Item No. 9.1.1
Design Review Committee
July 25, 2019

SUBJECT: **Case 22322: Substantive Site Plan Approval for 1872-1874 Brunswick Street, Halifax**

Application by Fougere Menchenton Architecture Inc.

Adjacent and below are illustrations showing this Streetwall Height Variance. The red line shows the only form which we request the Streetwall Height variance, and the green hatch shows the 1.35m high portion of the wall exceeding the 18.5m Streetwall height.

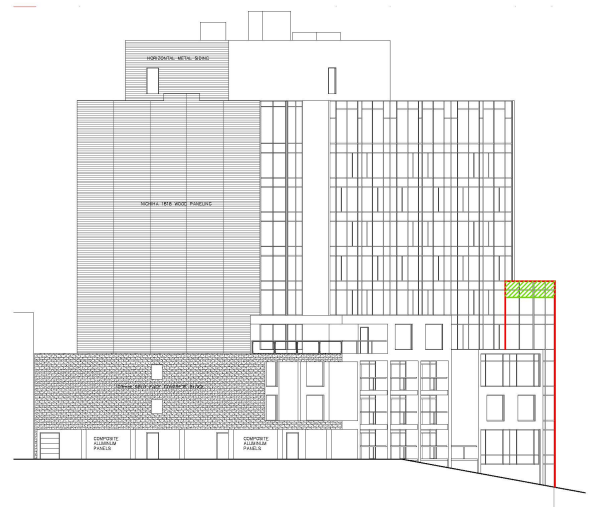
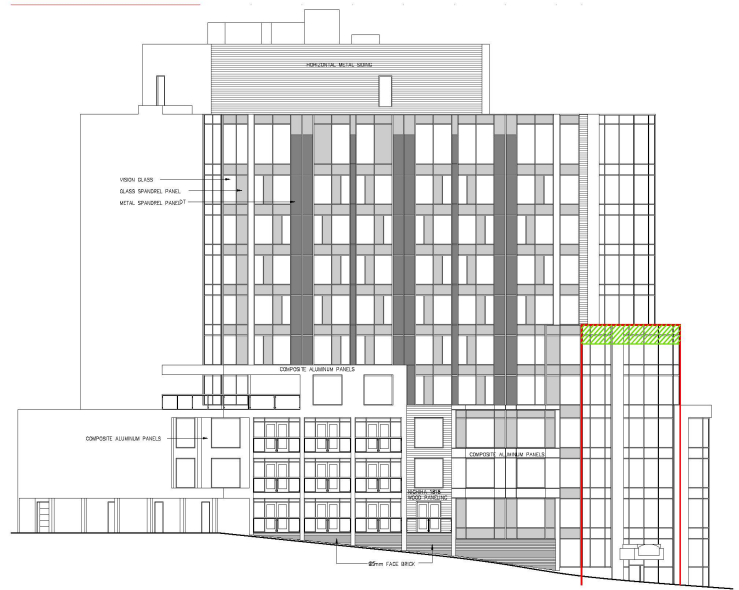
The proposed variance to the minimum streetwall height is requested to address the streetwall at Brunswick Street continuing around the corner, forming part of the corner architectural element of the proposed building to Gottingen Street. Here, the grade is steeply sloping and the streetwall (approximately 19.85 metres after turning the corner) needs to correspondingly step down to meet the permitted streetwall height. The proposed streetwall height is in keeping with the intent of the design manual to allow for corner element modifications. Staff recommends approval of the variance.

3.6.3b	The modification is for a corner element that is used to join streetwalls of differing heights; or	Yes	The streetwall façade on Brunswick continues around the corner, forming part of the corner architectural element, of the proposed building to Gottingen Street where the grade is steeply sloping and the streetwall needs to correspondingly step down to meet permitted streetwall height.

Adjacent are illustrations showing this requested variance for our Mid-rise Building Step-Back.

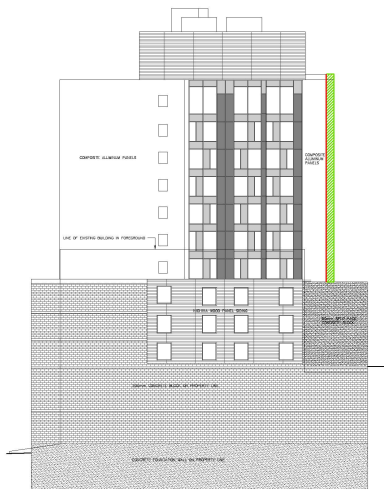
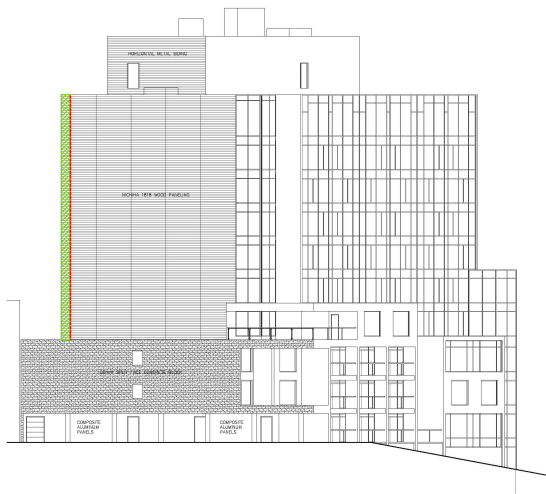
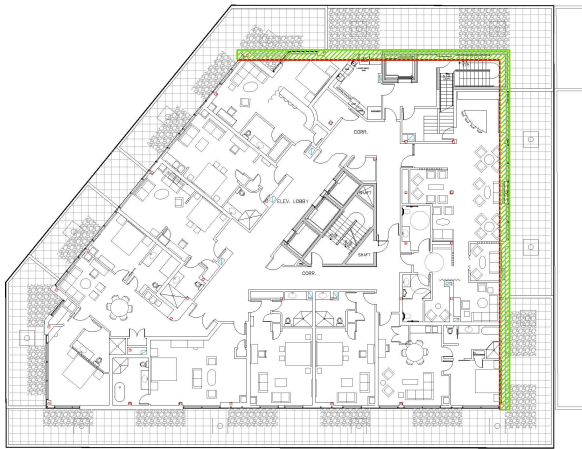
The requested variance is intended to address hotel industry operational standards for the central circulation core and specific length requirements for hotel rooms. The sloping nature and limited depth of the site divided delivery and pick-up services to two locations: a grade level area shared with the valet parking area at Brunswick Street and grade level access at Level three at the west elevation of the building. The floor area consumed for this particular circulation left minimal space to meet room length standards. The response to this was to request that the mid-rise building stepback be decreased. The requested modification to the required stepback recognizes the need for hotels to meet facilities standards in order to maintain and enhance Halifax's competitiveness as a tourist destination, thereby serving a positive benefit. Staff recommends this variance be approved.

3.6.5	Upper Storey Streetwall Stepback Variance Upper storey streetwall stepbacks may be varied by Site Plan Approval where:		
3.6.5a	The upper storey streetwall setback is consistent with the objectives and guidelines of the Design Manual; and	Yes	Section 10(4) of the Land Use By-law requires that the mid-rise portion of a building be set back 10% of the lot width from interior lot lines or 5.5 metres, whichever is less. Based on the lot width the required setback would be 4.3 metres. The request is for a stepback of 3.5m. This stepback of 0.8 metres is minimal and the proposed building remains consistent with the intent of the Design Manual.

Section	Guideline	Complies	Discussion
	improved heritage preservation or the remediation of an existing blank building wall.		would allow adherence to hotel industry standards for circulation and room size that recognizes the need for hotels to provide updated facilities to enhance Halifax's competitiveness as a tourism destination.

Setback for service elevator rooftop enclosure

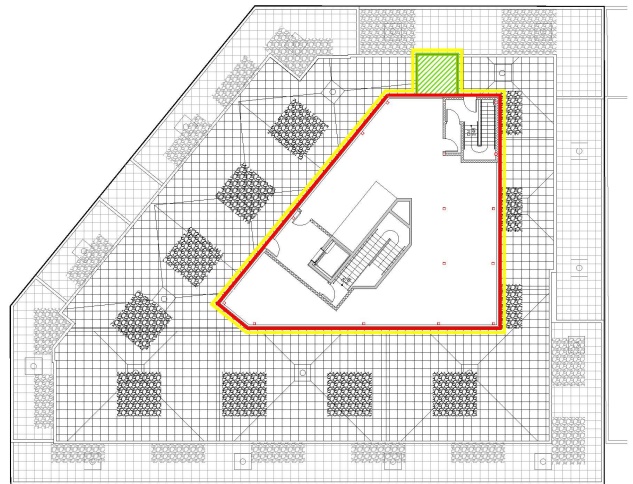
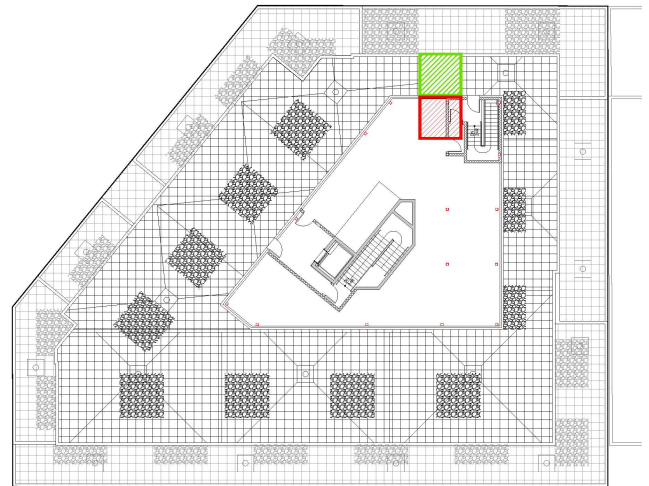
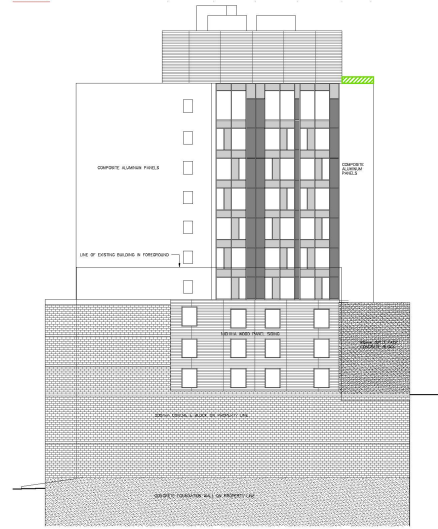
The requested setback variance does not change the proposed building setbacks from the property lines. Rather it is requesting the existing dimensions from the interior lot lines to the elevator enclosure be permitted by varying the required setback for high-rise buildings. Therefore, separation distances are not changed or reduced between abutting buildings and the proposal. Staff recommends this variance be approved.

3.6.2	Side and Rear Yard Setback Variance Side and rear yard setbacks may be varied by Site Plan Approval where:		
3.6.2a	The modified setback is consistent with the objectives and guidelines of the Design Manual; and	Yes	All other conditions of the Land Use By-law have been met for side and rear yard setbacks.

3.6.2b	The modification does not negatively impact abutting uses by providing insufficient separation.	Yes	The modification does not negatively impact abutting uses as the resulting separation will be sufficient because proposed west top of building facade is not
